Agenda Item #: 5

SUB-002733-2023

Lots 1-3, Block 138 and Lots 15-18 & The North 20' of Lot 14, Block 139 Pinehurst, Delaney's Addition to Spring Hill Resubdivision of and Addition to

APPLICATION NUMBER 5 DATE December 21, 2023

DETAIL SITE PLAN

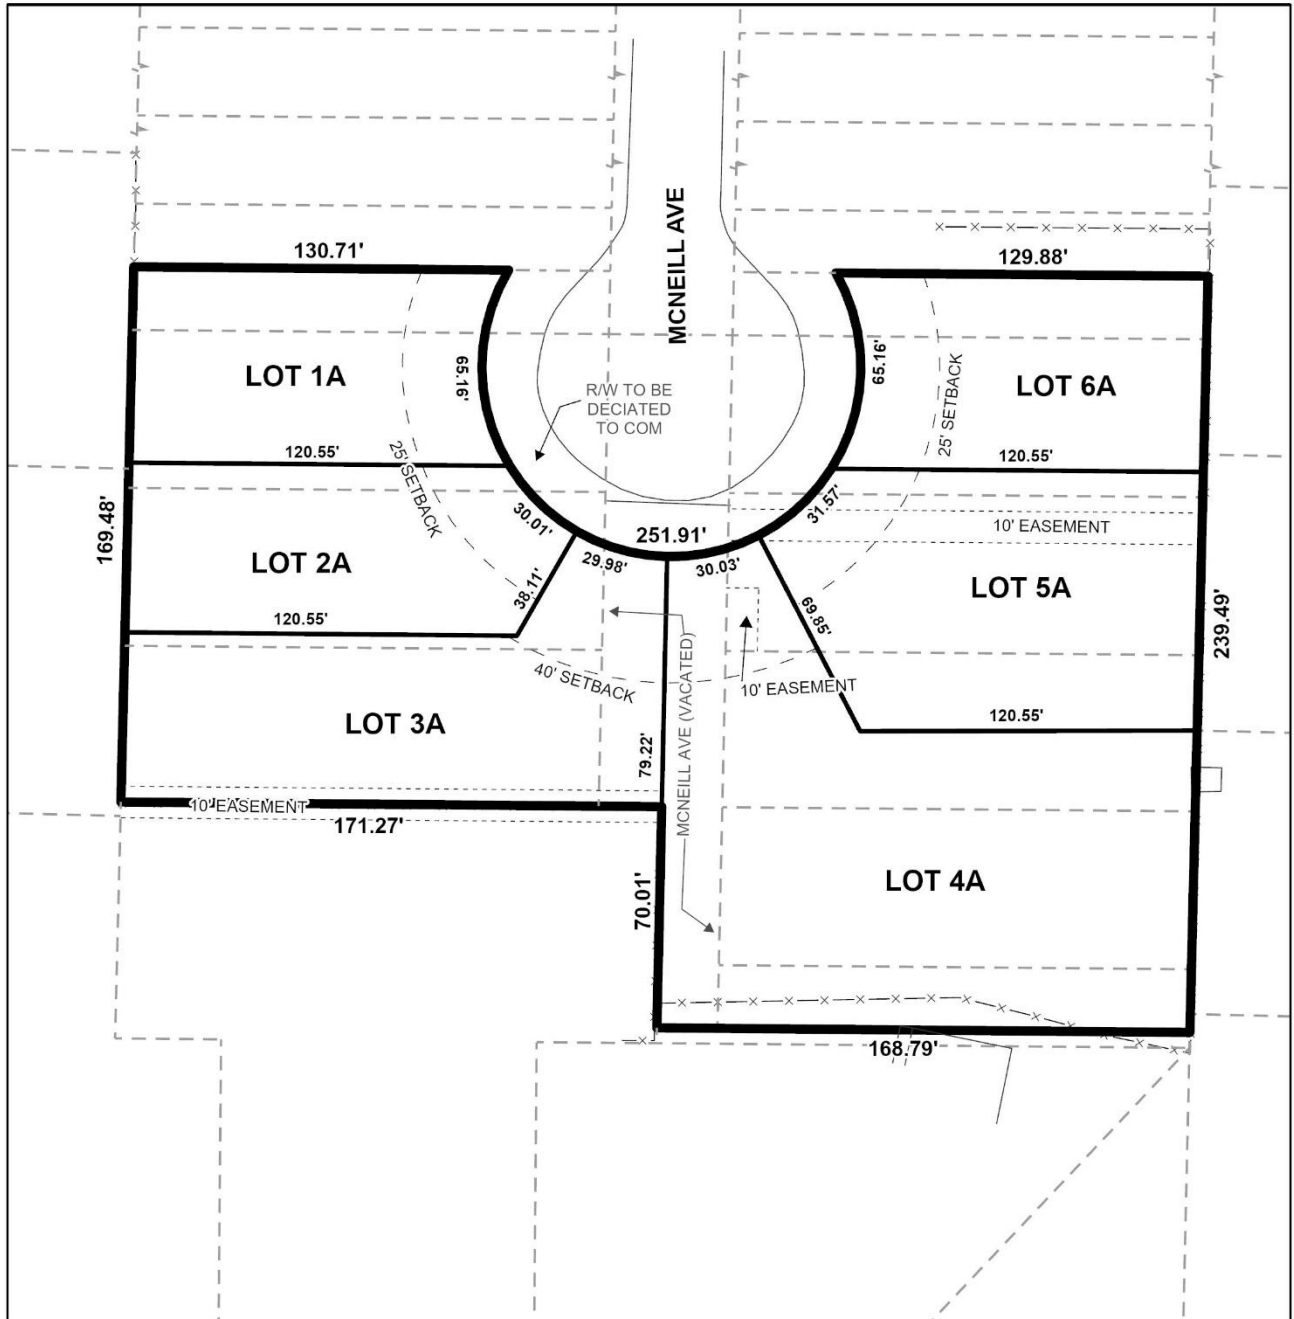
- B. Include all of the other information provided in the initial PLAT submitted 11/15/23.
- C. Show and label the correct MBSL. The label does not point to the revised MBSL.

- D. Provide and label the monument set or found at each proposed subdivision corner.
- E. Remove the NOTE about requesting front setback reductions.
- F. Add a note to the SUBDIVISION PLAT stating that as shown on the 1984 aerial photos LOTS 1A – 6A will share the historical credit of existing (1984) impervious area towards stormwater detention requirement per Mobile City Code, Chapter 17, Storm Water Management and Flood Control) as follows: LOTS 1A – 6A – NONE.

All proposed lots have frontage on the South terminus of McNeill Avenue, a cul-de-sac with a substandard 50-foot radius. The preliminary plat indicates dedication to provide a compliant 60-foot radius cul-de-sac, and this should be retained on the Final Plat, if approved. A compliant 25-foot minimum building setback line is indicated for proposed Lots 1A, 2A, 5A and 6A. A 40-foot minimum building setback line is indicated for proposed Lots 3A and 4A where each lot is at least 60-feet wide. If approved, the minimum building setback lines should be retained on the Final Plat as proposed on the preliminary plat.

Lots 1A and 6A would exceed the 60-foot minimum width requirement at the building setback line of Section 6 C.2.(b)(2) of the Subdivision Regulations. Lots 2A, 3A, 4A and 5A would not meet the 60-foot minimum width requirement, but they would meet or exceed a 50-foot width at the minimum building setback line. As the proposed subdivision is an addition to an older subdivision with substandard 50-foot lot widths, the allowance of substandard lot widths at the building setback line would seem in order, with a waiver of Section 6 C.2.(b)(2) of the Subdivision Regulations.

Section 6.C.2.(a) (1) of the Subdivision Regulations states that the minimum lot area shall be as defined in the Unified Development Code (UDC), and Section 64-2-5-E. of the UDC requires a minimum 7,200 square-foot area for lots in an R-1, Single-Family Residential Suburban District. Proposed Lots 1A, 2A and 6A would not meet the minimum 7,200 square-foot area requirement. The applicant's narrative states that in early communications with the City concerning the proposed subdivision, it was requested that the radius of the McNeill Avenue cul-de-sac be increased from 50 feet to a compliant 60 feet. It is further stated that this increase in radius reduced the area of each lot, and if the radius had been left at 50 feet, the smallest lot size would be approximately 7,327 square feet. Considering substandard lot sizes are common within the vicinity of the subject site, approval of the request may be appropriate. If approved, a waiver of Section 6.C.2.(a) (1) of the Subdivision Regulations would be required. The plat should be revised to label the lot sizes in both square feet and acres, or a table should be placed on the Final Plat providing the same information.

There are recorded sanitary sewer easements within the site. Therefore, a note should be required on the Final Plat, if approved, stating that no structure may be constructed or placed within any easement without the permission of the easement holder.

1. Revision of the Final Plat to meet the technical requirements of Section 5 C. of the Subdivision Regulations;
2. Retention of dedication to provide a 60-foot radius cul-de-sac at the South terminus of McNeill Avenue;

3. Retention of a 25-foot minimum building setback line for Lots 1A, 2A, 5A and 6A on the Final Plat as measured from any right-of-way dedication;
4. Retention of a 40-foot minimum building setback line for Lots 3A and 4A on the Final Plat as measured from any right-of-way dedication;

5. Revision of the plat to label each lot with its size in both square feet and acres on the Final Plat, or the furnishing of a table on the Final Plat providing the same information;

6. Placement of a note on the Final Plat stating that no structure may be constructed or placed within any easement without permission of the easement holder;
